Revised General Development Plan (GDP) Review 1 Mahalaxmi Bayonne Urban Renewal, LLC (P-23-017)

One Flagship Street
Block 751, Lots 1.11, 1.14, and 1.15
Harbor Station South (HS-2) Redevelopment Area
Bayonne Metropolitan Harbor District (BMHO)

January 25, 2024

Original GDP Outline in Red, Areas of Proposed Amendment Indicated in Yellow

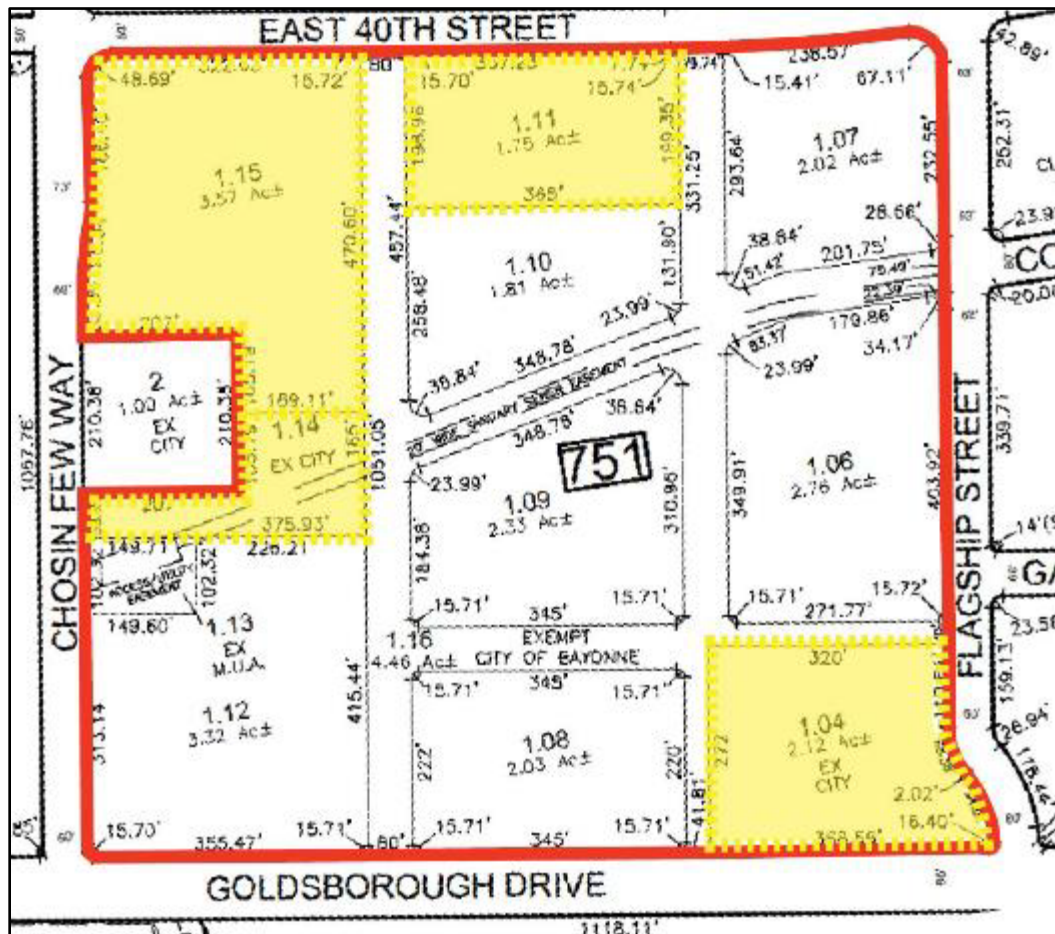
- 1.1. **Proposal.** The applicant seeks to amend the General Development Plan (GDP) for the Harbor Station South Redevelopment Area as established by *The City of Bayonne Planning Board Resolution P-19-022* adopted on September 23, 2019. The resolution encompassed Block 751; Lots 1.04, 1.06, 1.07, 1.08, 1.09, 1.10, 1.11, 1.12, 1.13, 1.14, 1.15, and 1.16. The proposed amendment is limited to Lots 1.04, 1.11, 1.14, and 1.15, totaling 6.24 acres, as indicated in yellow in the following image, with the GDP area outlined in red.

Lot 1.04 as indicated in the proposed amended GDP. The light gray portion of the building has already been developed.

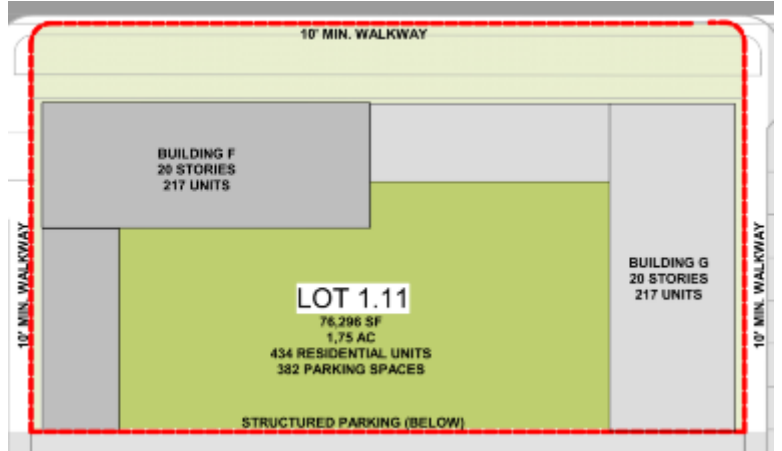
2.1.1. Lot 1.04. Lot 1.04 is the only parcel within the GDP that has been developed. An existing five story building with 97 units and 97 parking spaces⁴ was developed pursuant to a prior Board approval. Next to the building at its rear, “Building E” is indicated for future development, containing an 18-story building with 71 residential units and 218 hotel rooms, served by 289 parking spaces (one space

for each unit and one space for each hotel room). Lastly, 3,120 sf. of commercial space is either proposed, existing, or would be a combination of both conditions. This is a change from the original GDP. The original GDP included the 97 unit building, but the rear portion was originally indicated as “Building A2” and was intended to contain 12 stories with 272 residential units and 107 parking spaces. Additionally, this parcel was slated for 12,769 sf. of commercial space.

Lot 1.11 (above) and Lot 1.14 (below) as indicated in the proposed GDP.

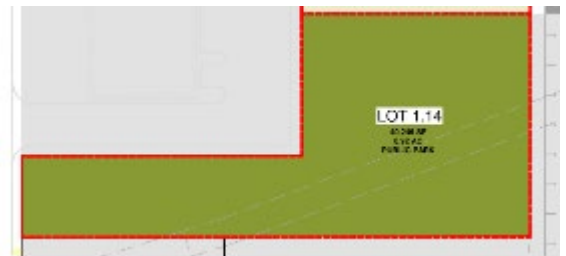
2.1.2. Lot 1.11. Two buildings and structured parking are proposed on Lot 1.11. It consists of Buildings F and G, both of which are 20-story towers each containing 217 residential units (for a total of 434 residential units). A parking structure is also proposed containing 382 parking spaces. The “Commercial Area Summary” table located on sheet 3 of the GDP plan indicates that Lot 1.11

will contain 21,612 sf. of commercial space. This is a change from the original GDP. The original GDP included a 10-story building labeled “Building D3” with 207 residential units on Lot 1.11. Additionally, a 76,296 sf. parking structure was proposed.

2.1.3. Lot 1.14. Lot 1.14 is proposed to contain a public park encompassing the entirety of the parcel totaling 0.92 acre (40,246 sf.). This appears to be in line with the original GDP which was indicated as a “Park Lot” and encompassed the same area.

Lot 1.15 (image to the left) as indicated in the proposed GDP. Building A has received site plan approval.

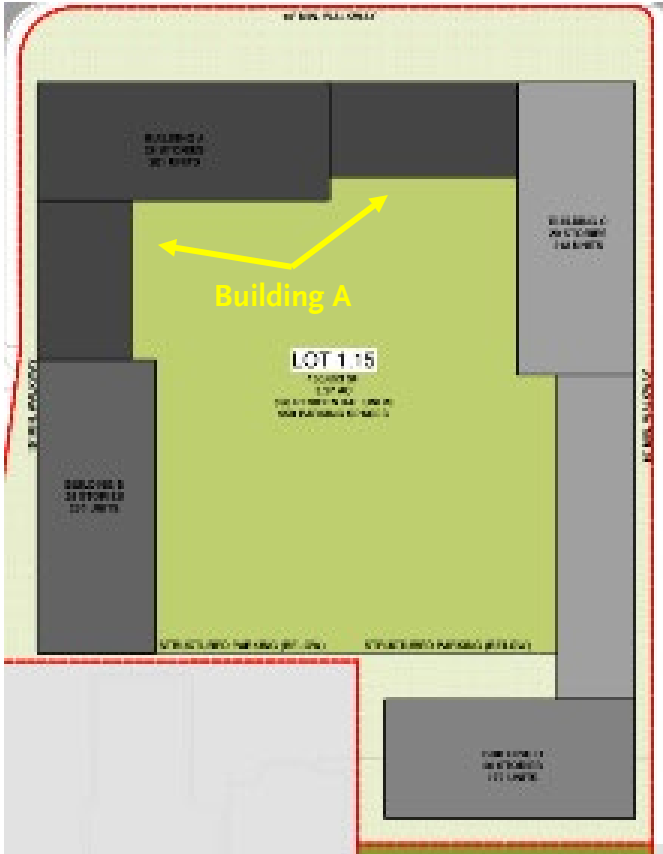
2.1.4. Lot 1.15. Lot 1.15 is proposed to contain four buildings, indicated as Buildings A, B, C, and D. the size of the lot is 3.57 acres. Building A was the subject of an approved site plan application in 2023. Building A is 26 stories and has 281 residential units. Building B is 25 stories and 234 units. Building C is 20 stories with 213 residential units, and Building D is 20 stories and contains 170 residential units. The total number of residential units is 898. The GDP indicates there will be 950 total parking spaces in structured parking, though the configuration of the parking is unknown outside of the already approved Building A. The “Commercial Area Summary” table located on sheet 3 of the GDP plan indicates that Lot 1.15 will contain 15, sf. of commercial space. See vignette of Lot 1.15 on the following page.

This is a change from the original GDP. As detailed at the time of site plan application for Building A, the GDP previously contained a 10 story hotel with 218 rooms, two eight story buildings with 91 residential units and 117 residential units, a six story parking garage with 567 parking spaces, and a surface parking lot with 89 parking spaces.
